CORRIDOR Road Safety Audit

SR 8 / SR 10 / US 23 / US 29 / US 78 / US 278 /
PONCE DE LEON AVENUE NE / SCOTT BOULEVARD
ATLANTA AND DECATUR | DEKALB COUNTY | GEORGIA

Prepared for the Georgia Department of Transportation

Prepared by Gresham, Smith and Partners

FIGURE 5-72. SUGGESTED IMPROVEMENTS AT WEST PONCE DE LEON AVENUE, NORTH PARKWOOD ROAD, AND EAST PARKWOOD ROAD.

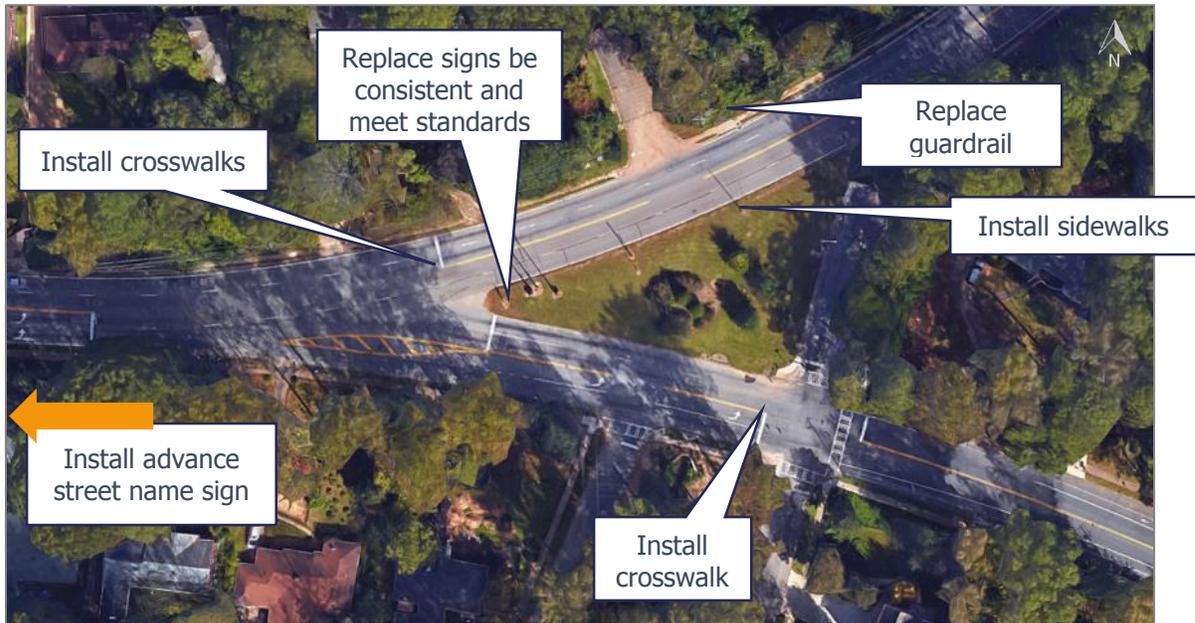
SAFETY BENEFIT	LEVEL OF EFFORT	TIME FRAME	COST
1. Trim vegetation to make signs more visible.	High	Low	Short Term	Low
2. Replace or remove signs in triangular median as needed and consider installing an advance road name sign for West Ponce de Leon Avenue.	Moderate	Low	Short Term	Low
3. Install an advance signal warning sign for eastbound drivers.	High	Low	Short Term	Low
4. Install sidewalks in triangular median to facilitate safer pedestrian access.	High	Low	Short Term	Low
5. Install crosswalks across Scott Boulevard.	High	Low	Short Term	Low
6. Redesign the intersection to create an offset signalized intersection with all three streets.	High	High	Long Term	High

FIGURE 5-81. SUGGESTED IMPROVEMENTS FOR MERRILL AVENUE INTERSECTION.

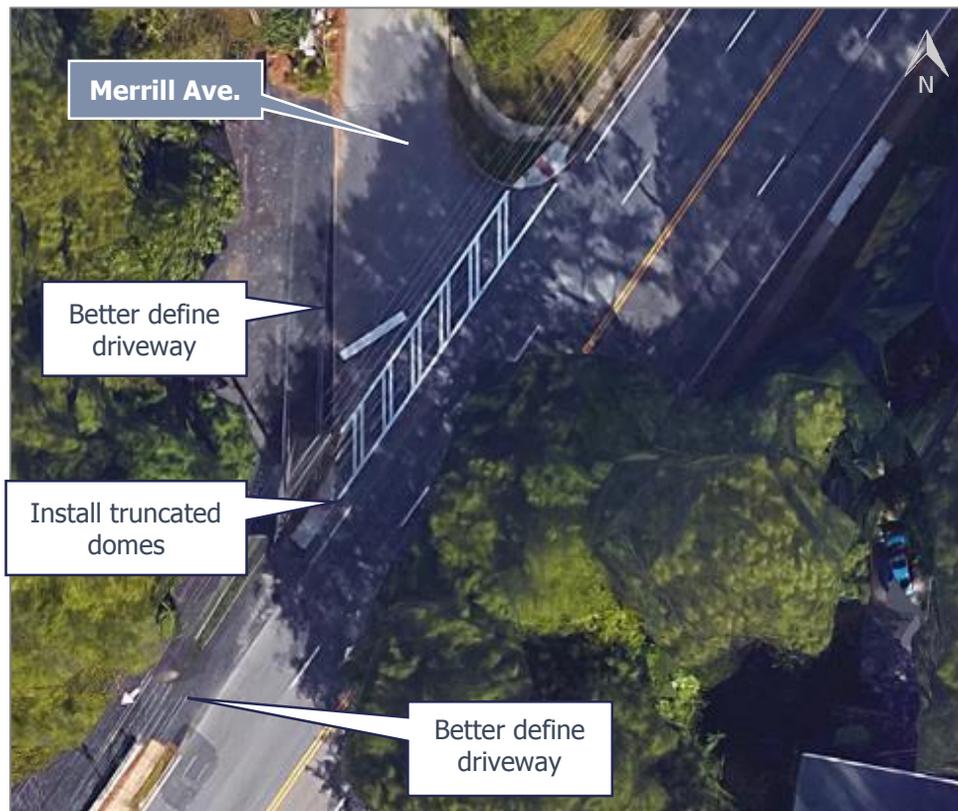
SAFETY BENEFIT	LEVEL OF EFFORT	TIME FRAME	COST
1. Better define the driveway at Venetian Pools and ensure pedestrian safety crossing the driveway.	High	Moderate	Intermediate	Low
2. Study ways to reduce the skew angle at Merrill Avenue and provide better sight distance. Implement feasible recommendations as appropriate.	Moderate	Low	Intermediate	Low

FIGURE 5-87. SUGGESTED IMPROVEMENTS TO INTERSECTION AT COVENTRY ROAD.

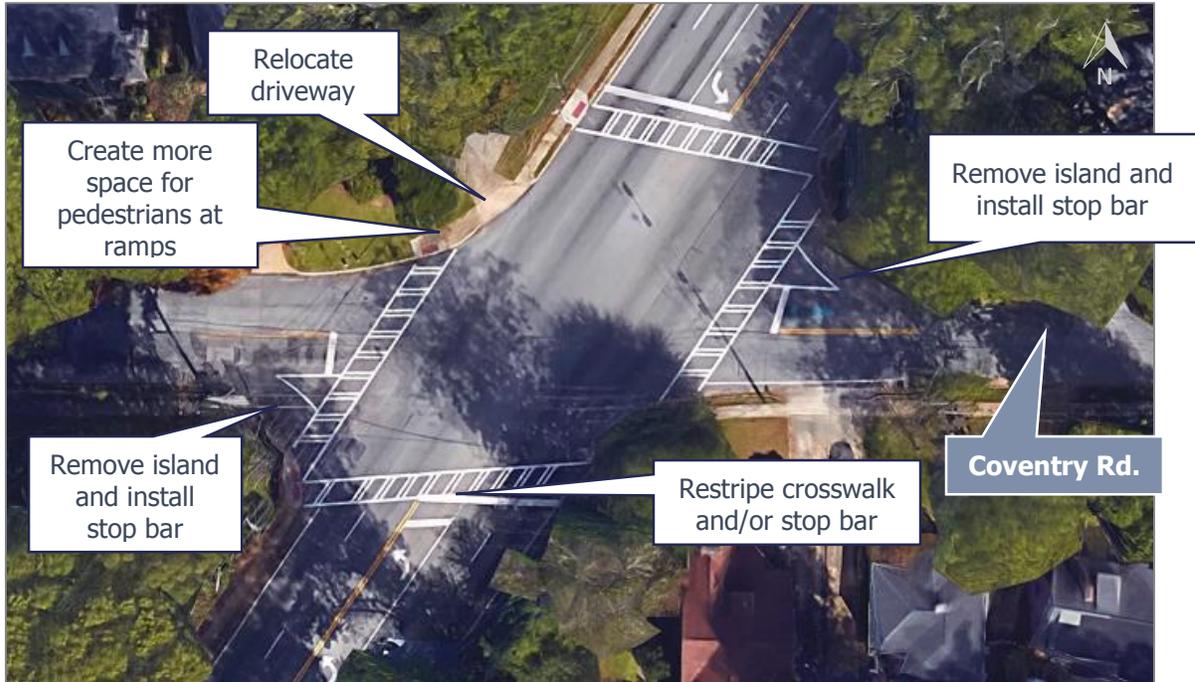
SAFETY BENEFIT	LEVEL OF EFFORT	TIME FRAME	COST
1. Replace or reposition pedestrian signs and signals so they are more visible to pedestrians.	Moderate	Low	Short Term	Low

4. Remove painted islands.	Moderate	Low	Short Term	Low
5. Restripe stop bar and/or crosswalk so they no longer overlap.	High	Low	Short Term	Low
6. Consider a recommendation from bicycle and pedestrian groups to raise the curb at intersection corners.	Moderate	Low	Intermediate	Low

10. Carry out the planned quick-response project to square off the intersection approaches.	High	Moderate	Intermediate	Moderate
